ASSESSMENT REPORT

Modification to Edmondson Park South MP 10_0118 MOD 3

Figure 3: Aerial photo of STP and oxidation ponds (source: Proponent's EA)

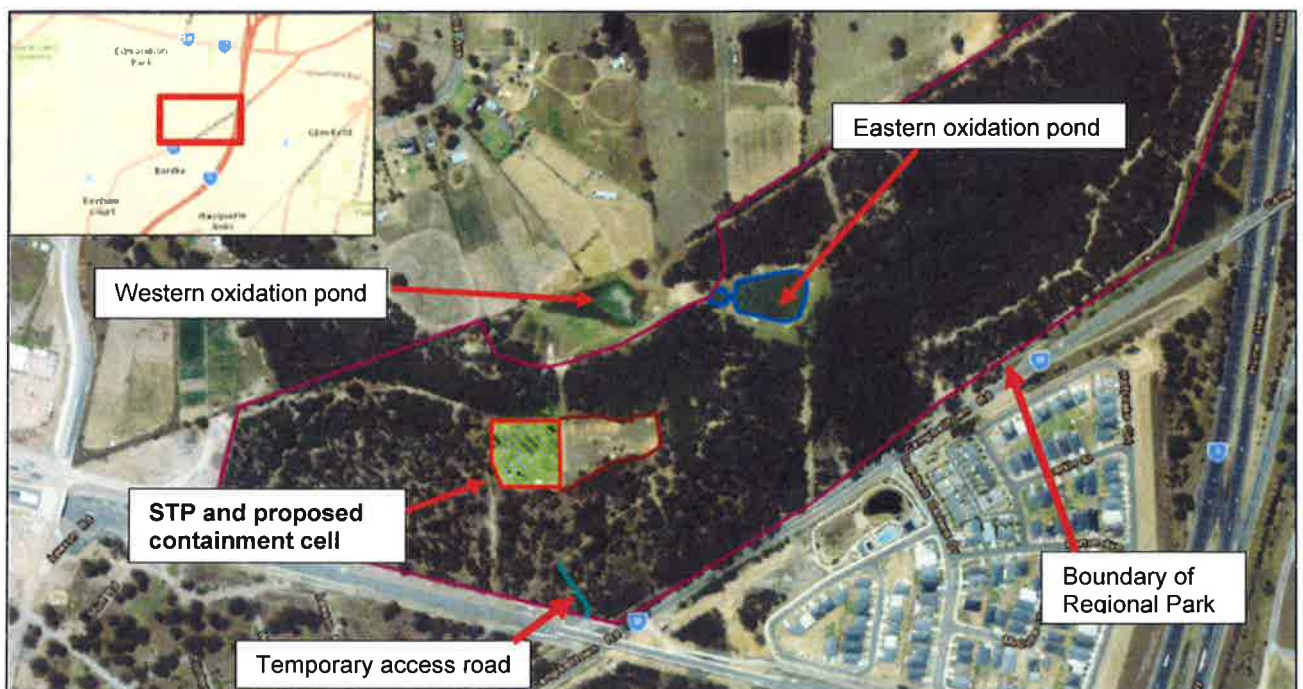
The Proponent's preferred remediation measure includes on-site containment of asbestos impacted material, lead impacted material and other sediment potentially containing TPH and EColi, once treated. The proposed containment cell would be located within the general footprint of the existing STP (see **Figure 3**).

Council does not support the strategy for on-site containment and would prefer excavation and disposal of the contaminated materials off-site as it would result in the best long-term outcome in terms of mitigating risks to human health and the environment.

The Department has carefully considered the preferred remediation strategy and the comments made by Council and agencies and is satisfied the remediation strategy is appropriate, noting:

- the containment cell would not be located on land to be transferred to Council, but rather on land to be transferred to the NPWS, being part of OEH. OEH has not raised any concerns with the proposed on-site containment strategy; and
